CUSTOMER Digikey	CUSTOMER DRAWING NUMBER Please see below	REV. NO.	TODAYS DATE 2/1/2016
CUSTOMER CONTACT NAME	TITLE	PHONE NO./EXT	
JKL PART NUMBER 7632	PART DESCRIPTION T-1 1/4 Bi Pin Lamp 28V	FAX NO.	
JKL CONTACT NAME Sherry Carpenter	PHONE 818-896-0019	EMAIL: <a href="mailto:scarpenter@jklamps.com">scarpenter@jklamps.com</a>

REASON FOR NOTICE:  
JKL Item #7632 is no longer being produced due to decreased demand  
Ref. Digikey 7632JK-ND

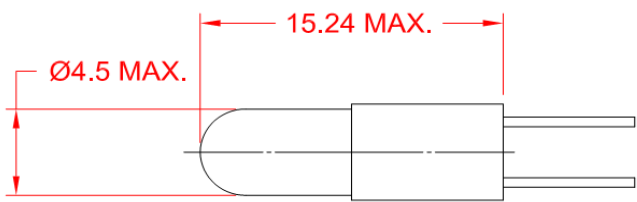
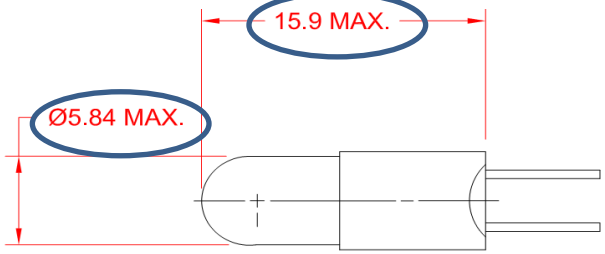
<p><b>Obsolete Item:</b> #7632 T-1 1/4 Bi Pin Lamp 28 volts .040 AMPS .320 MSCP 2500 Hours</p> 	<p><b>Suggested Replacement Item:</b> #7327 T-1 3/4 Bi Pin Lamp (Digikey 7327JK-ND) 28 volts .040 AMPS .340 MSCP (brightness) 4,000 Hours Life</p>  <p>The suggested replacement lamp has a slightly larger diameter and overall height. The pins and pin spacing is the same.</p>
--	--
